Information on how to read the document

Review 1

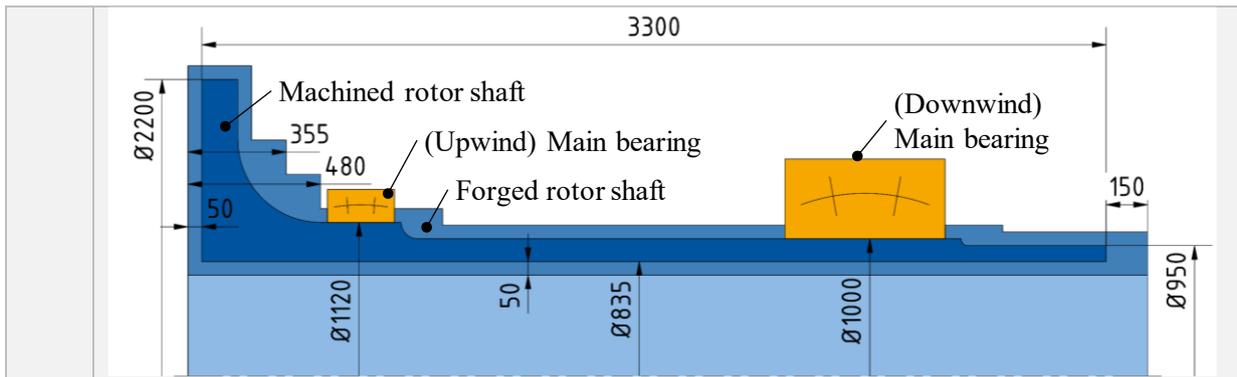
| RC 5	Line 80 and Figure 1 Terminology in this sentence, the figure, and the remainder of the paper are not quite the same, leading to a little bit of confusion. I believe it would be clearer to label both the "Upwind main bearing" and "Downwind main bearing" rather than just one "Main bearing" in the figure. Are the assembly components the same as the red components? Also, the "Machine frame" is labeled twice for both the green and grey components, with the green component (I think) called the "Main bearing housing" in the remainder of the paper (for example, in Section 3.3.3 and Table 5) and the grey component separate and not in the scope of the study. Additionally, the text states "The bearing housings…connect…gearbox to the azimuth bearing". I don't believe this is correct: as far as I can tell from the figure the gearbox is only connected to the grey "Machine frame", but not the "Main bearing housing". But I could be wrong here. It does not seem to be worth mentioning the azimuth bearing, as it is not shown in the figure and not in the scope of the paper either.

AR	*Adjustment of bearing labels in Figures 1-3* "Are the assembly components the same as the red components?" => Yes; for the other variants, they are indirectly considered trough the bearing housing mass *Adjustment of text and Figure 1 for better distinction between bearing housing and machine frame*
AC	Lines 82-84 The bearing housings are ~~integrated into the~~ combined into one cast ~~machine~~ frame, which is connected to the machine frame ~~and connect both main bearings and the gearbox to the azimuth bearing of the nacelle~~ (see Fig. 1).
	New Figure 1 New Figure 2

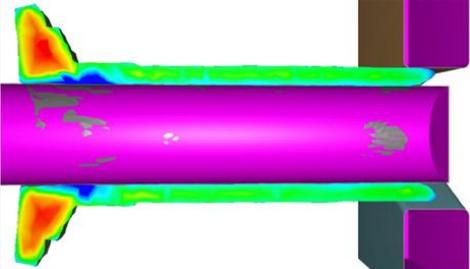
RC 3	Line 37
	I am not sure I understand the explanation here regarding a higher inner shaft diameter, section modulus, area, and outer shaft diameter. A fixed section area A and outer diameter D means a fixed inner shaft diameter d as well. In looking at Figures 2 and 3, it appears the outer diameters are similar (1000 mm), but the inner diameter and section area of the AHD shaft in Figure 2 is smaller than the case diameter shaft in Figure 3.
AR	Regarding the section modulus, the explanation assumes that the cross-section area of the shaft (=annulus) is fixed. In this case the outer diameter is a function of the inner diameter ($D = \sqrt{4A/\pi - d^2}$ and similarly the section modulus (S = f(A, d)). In this case, a larger inner diameter results in a larger section modulus (see the following figure), which enables the transfer of higher

bending moments ($\sigma = M/S$) or reversely a cross-section reduction. As cast iron has a lower tensile strength than AHD steel, an AHD steel shaft can have a larger inner diameter than a cast shaft for the same outer diameter and loads. → *Line changed for better understanding*
AC	<u>Lines 38-39</u> A larger inner shaft diameter (d) enables higher section modulus ($S_{Bending}$, see Eq. (1)) for a fixed shaft cross- section (A; ~~with~~ outer shaft diameter D calculated given Eq. (2)).

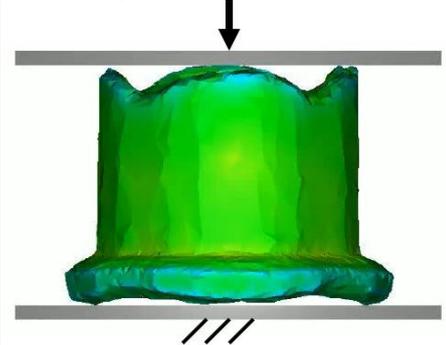
RC 9	Line 242 Again, not being an expert in this area, I am not familiar with the term "…axial upsetting". Can a brief description be added here? Does this refer to standing the shaft upright, such that gravity has some compressive effect on it?
AR	General summary of the forging steps: During hollow forging, the shaft is threaded on to a mandrel. Using a fixed die below and a moving die above, the material is compressed. This results in a reduction in diameter and an axial widening of the material. *Image: Hollow forging a shaft* When forging the flange, the straight flange starts to deform into a funnel-shape. To ensure that the shaft geometry can be machined from the forging geometry, large axial surcharges (allowances) are needed. *Image: Funnel-shaping of the left-sided flange (forging simulation)* To reduce the surcharges, it is necessary to straighten the flange. This is achieved by compressing the shaft axially without a mandrel inside. *Image: Straightening of the flange by axial upsetting the flange (forging simulation)*

AC	Lines 258-262 By upsetting (compressing) the entire shaft in the axial direction between the forging steps, the flange area can be straightened, reducing the allowances required to compensate for the funnel-shaped collapsing flange areas and thus significantly reducing the masses in this area. Axial upsetting between

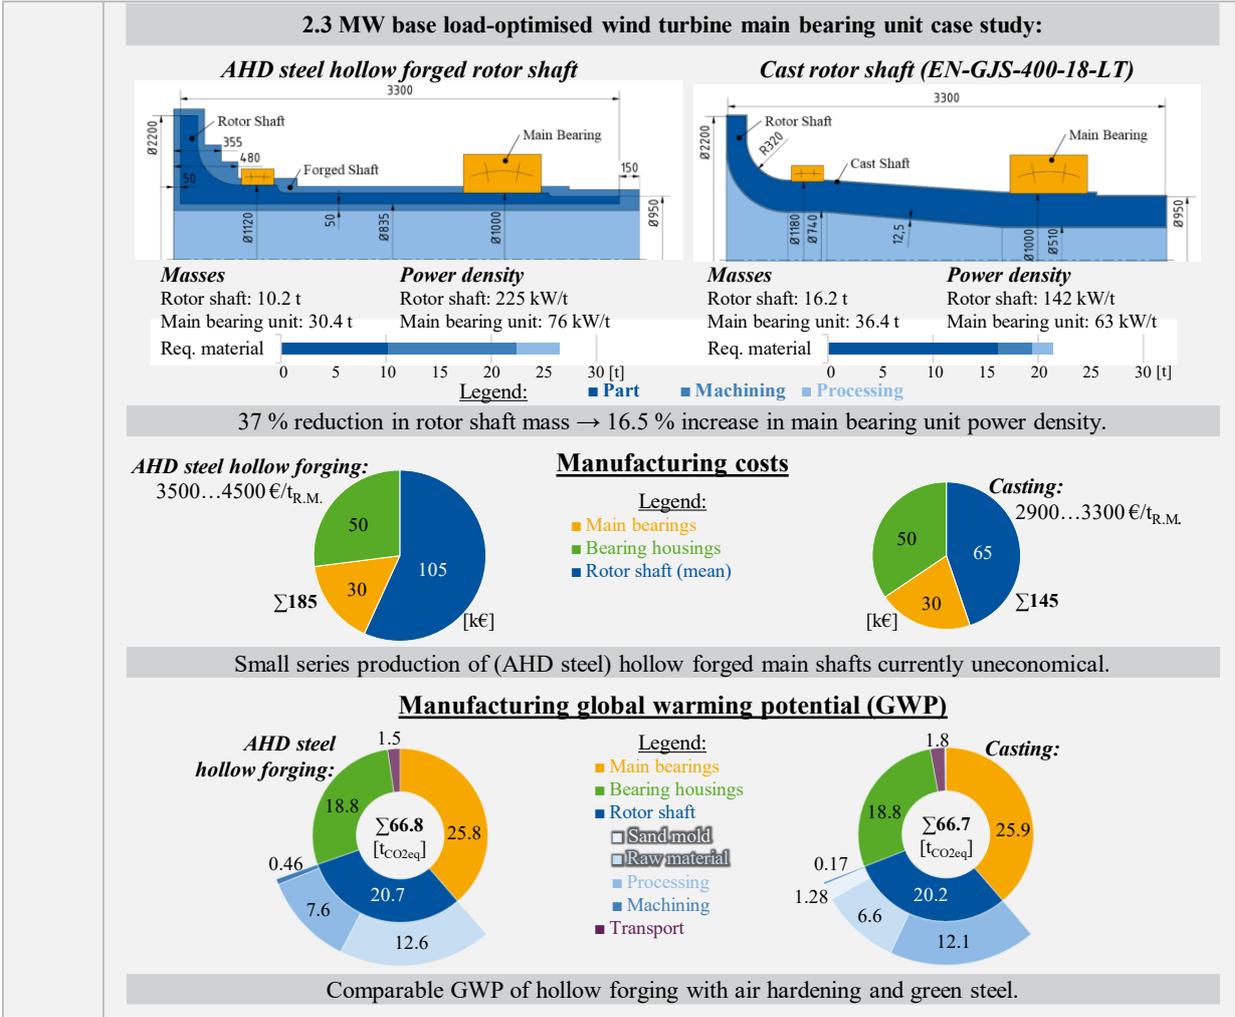
RC 12	Figure 6 In the middle figure, what does "Rotor shaft (lower)" and "Rotor shaft (spread)" mean? I don't believe I've seen this explained yet. Does this indicate the lower bounds and upper bounds for the shaft (i.e. the spread)?
AR	Adjustment of Figure 6 – Manufacturing costs for better understanding: - Removed cost range of rotor shaft and replaced them by mean value - Scaling diagrams such that the cheaper cast variant has a smaller circle (area ~ costs)
AC	New Figure 6 (repositioned to match layout)
